WTCI Documents Database - Data Entry Report

Sender ID No.: SOM Box 4102
Primary Organization: SOM
Forwarded by: Tully, Bernard
Forwarded by (Org. Name): Morse Diesel
Document ID Number: SOM Box 4102
Document Author: Tully, Bernard
Document Author 2: NA, NA
Document Author 3: NA, NA
Doc. Author (Org. Name): Morse Diesel
Document Addressee: Ryan, John
Doc. Address. (Org. Name): Centrifugal Associates, Inc.
Document Title: Salomon Brothers Fuel Oil Piping
Attachments: No
Attachment Title(s):

RE: SBI - World Trade Center

PROJECT: SALOMON BROTHERS AT 7 WTC		TITLE: UNDERGROUND FUEL OIL PIPING	
PROJECT NO: 8822440.00	DATE: 11-9-89	SCALE: 1/4" = 1'-0"	DETAIL DRAWING NO: SK-FOT-1

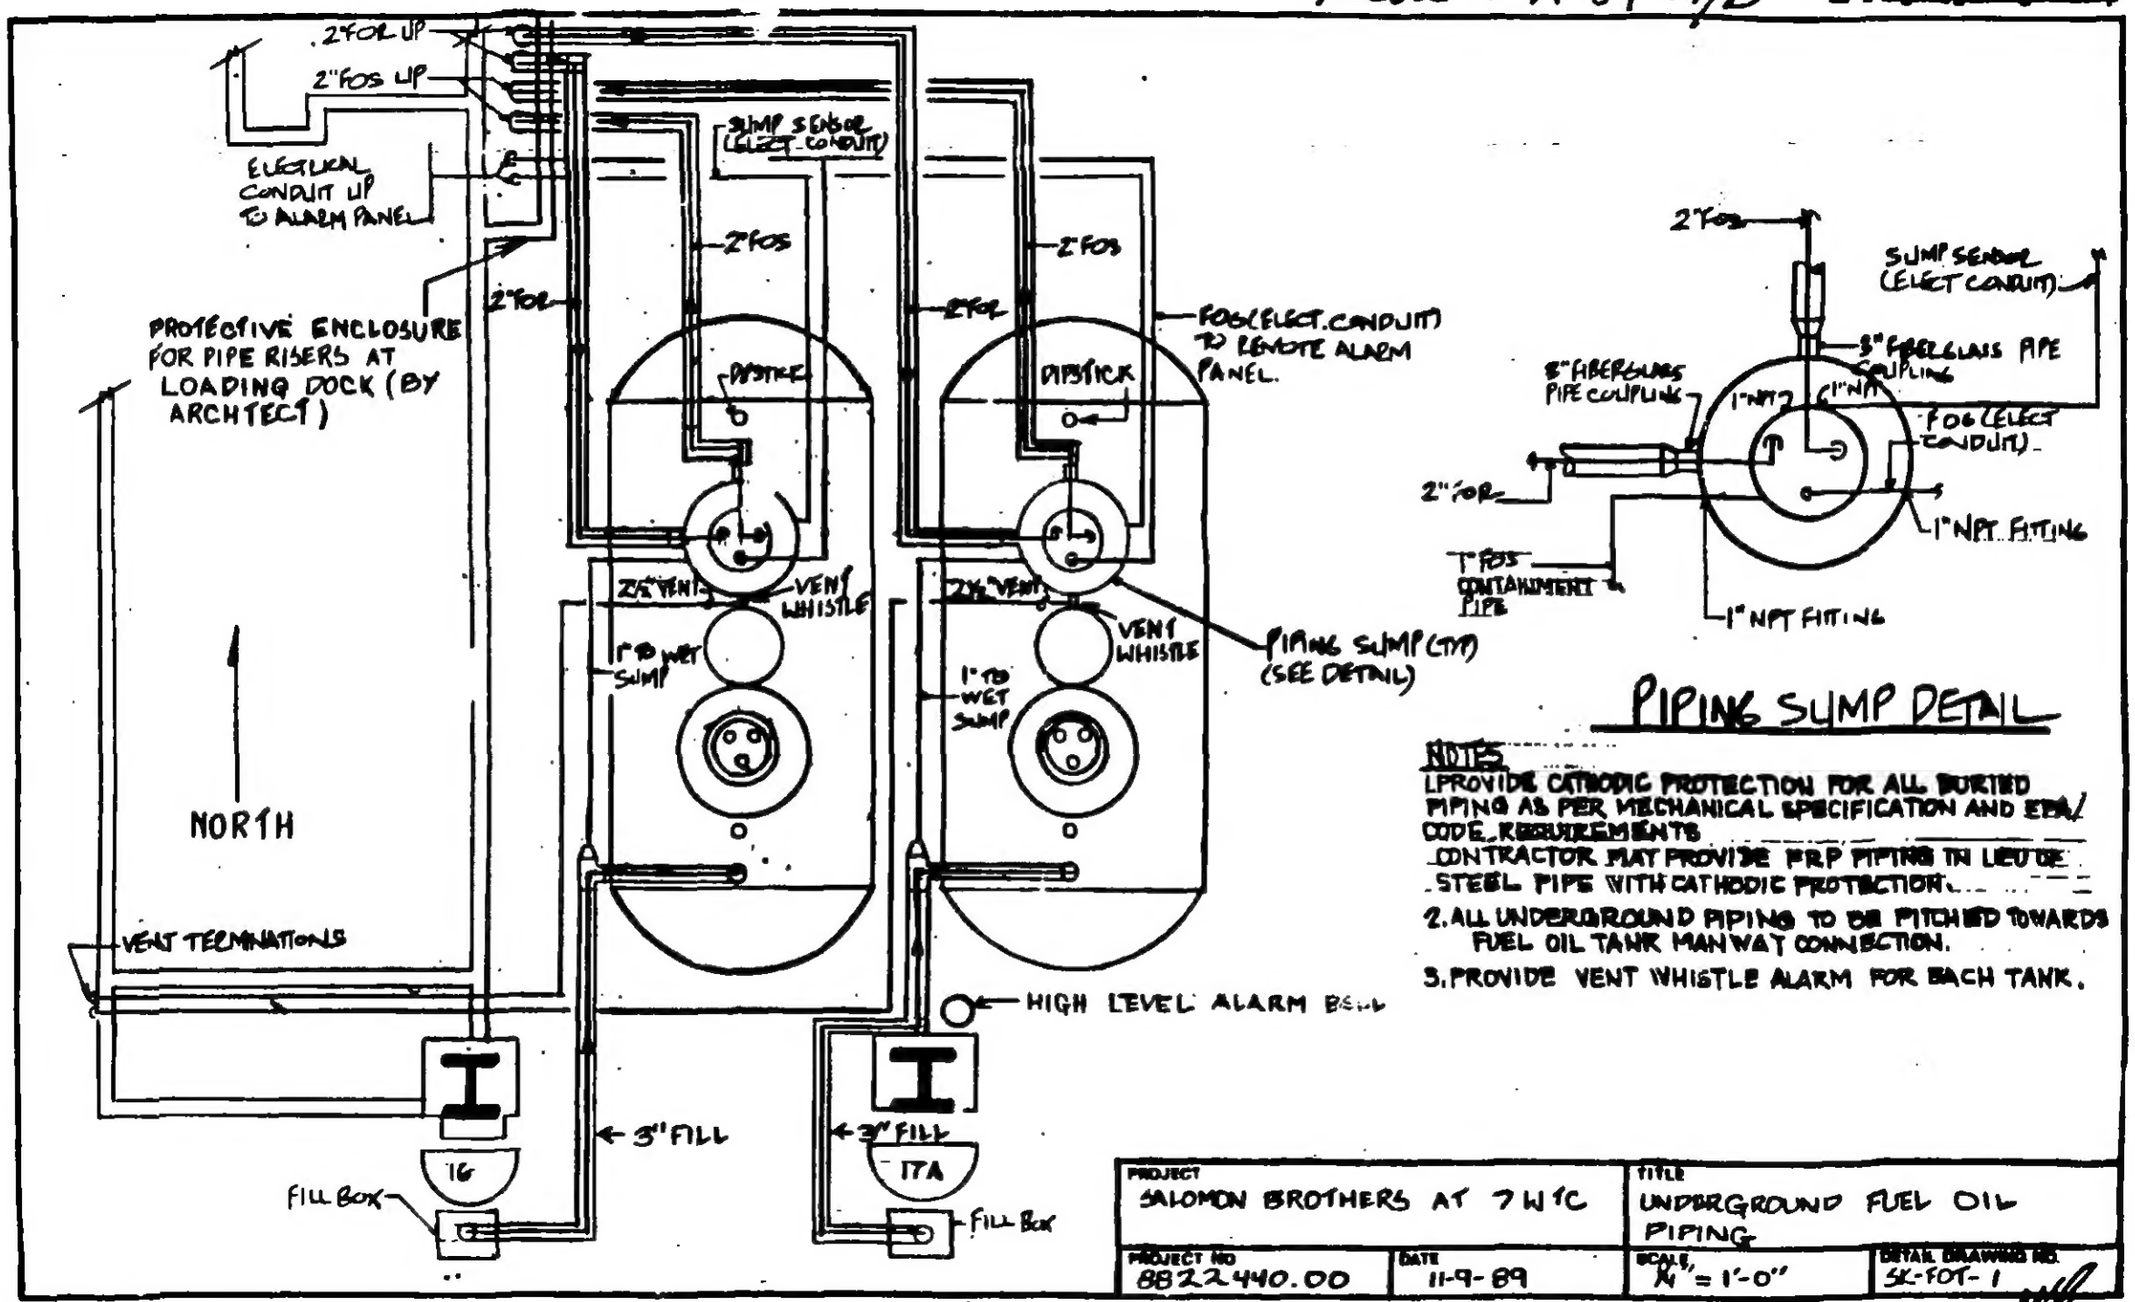
You are directed to proceed with the installation of your fuel oil piping as shown on attached Flack and Kurtz sketch SK-F02-1 Dated 11-9-89. If there are scope changes or work N.I.C. advise the writter.

Prepare a drawing detailing dimensions, pipe sizes elevations, cathodic protection etc. for approval.

This sketch supersedes the MI.1 "B" action from Flack and Kurtz.
